TECHNICAL INFORMATION

Subject ▶ Change of Pad 150

For Models ▶ BO6030, BO6040

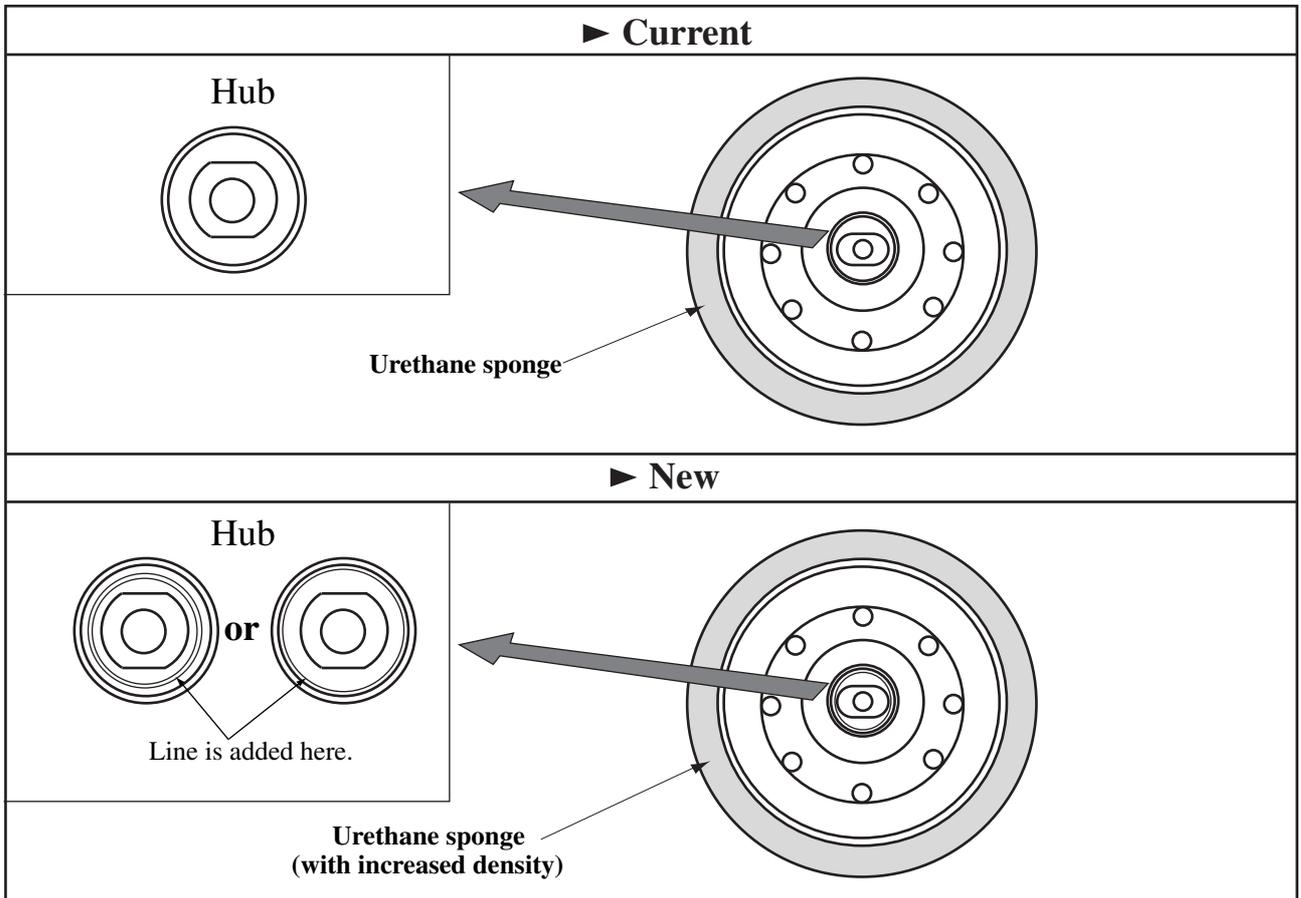
Description ▶ To enhance the durability of Pad 150, the density of urethane sponge has been increased. A line has been added on the hub of the new Pad 150 to distinguish the new Pad 150 from the current one as illustrated below.

Item No.	Current part	Q'ty	I/C	New part	Q'ty	Note
BO6030 : 046	Pad 150	1	←	Pad 150 (Soft)	1	Use the current pad 150 in your stock as a replacement part for BO6040. Do not use it for BO6030.
BO6040 : 033	743063-0			193299-5		
BO6030 : F12	Pad 150 (Soft)	1	←	Pad 150 (Soft)	1	
BO6040 : F03	794605-3			193299-5

Item No.	Current part	Q'ty	I/C	New part	Q'ty	Note
BO6030 : 046	Pad 150	1	←	Pad 150 (Soft)	1	Use the current pad 150 in your stock as a replacement part for BO6040. Do not use it for BO6030.
BO6040 : 033	743063-0			193286-4
